REMARKS

Application No. 09/778,371

AMENDED CLAIMS MARKED UP TO SHOW CHANGES
SUBMITTED IN ACCORDANCE WITH 37 CFR 1.121(c)(1)(ii)
IN RESPONSE TO OFFICE ACTION OF JULY 30, 2002

Fig. 2

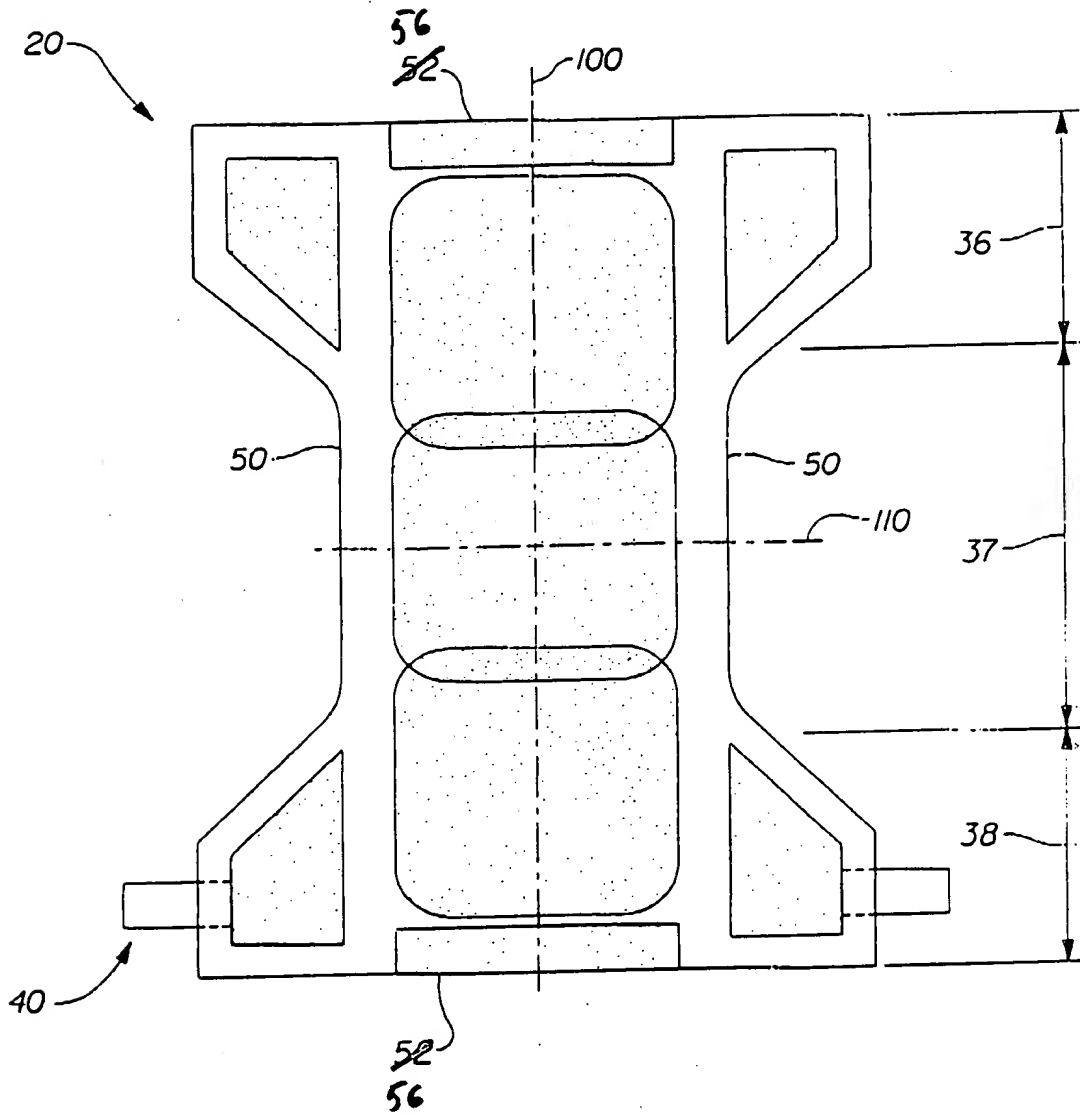
- Figures 1 and 2 have also been amended to include reference number 56 to define both waist edges as described on page 7, line 8. The paragraph bridging pages 4 and 5 has been amended for consistency.
